CO-OP MINING COMPANY

RE: Co-Op Bear Canyon Mine ACT/015/025
Stipulation Response 1/21/86

Stipulation 817.44-1-TM (Rock gabion)

LOOSE ROCK CHECK DAM

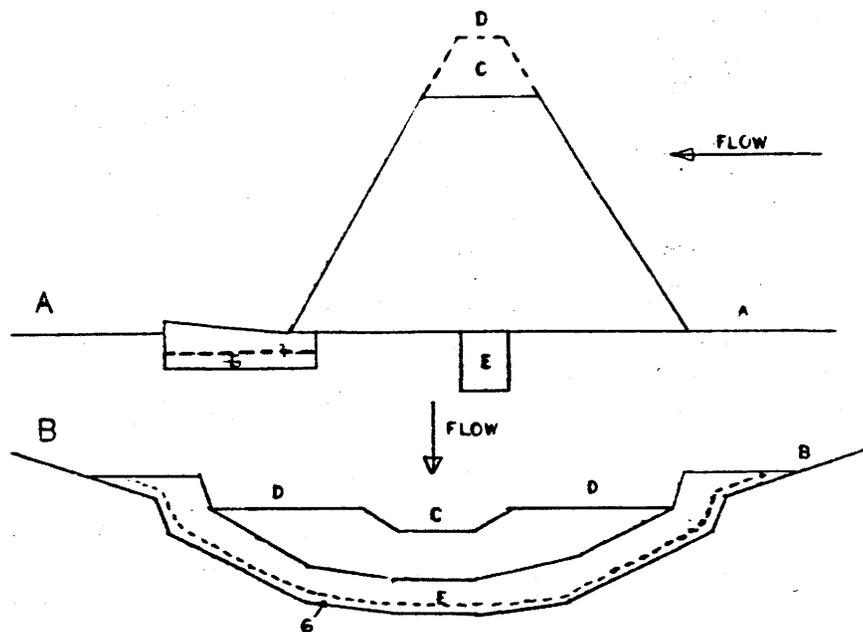
Stipulation 817.44-1-TM (Rock gabion)

Please find attached a rock gabion structure design which will be utilized by Co-Op for both interim and final reclamation (See figure 7-G).

1. A well-graded distribution of angular rock from 6-24 inches must be used. The angle of rest for this angular rock should correspond to a slope ratio not less than 1.5 to 1.0. The structure shall be 24-30 inches high. The angular rock shall be placed so as to form an 18-inch wide by 5-inch deep notch in the center of the creek channel to form a centralized spillway.

2. The keyway must be 24 inches wide and deep and excavated into the streambed and banks. The keyway into the banks must be 36 inches deep.
3. The apron section must be 10 feet long and placed with an adverse slope of six inches over the 10 foot length. A filter blanket (two inch minus material, six inches deep) must be placed under aprons. Riprap side slope protection measures for the length of the apron and two feet above the gabion crest must be included. The angle of rest for the 6-24 inch well-graded material used to construct the gabion must be strictly adhered to.
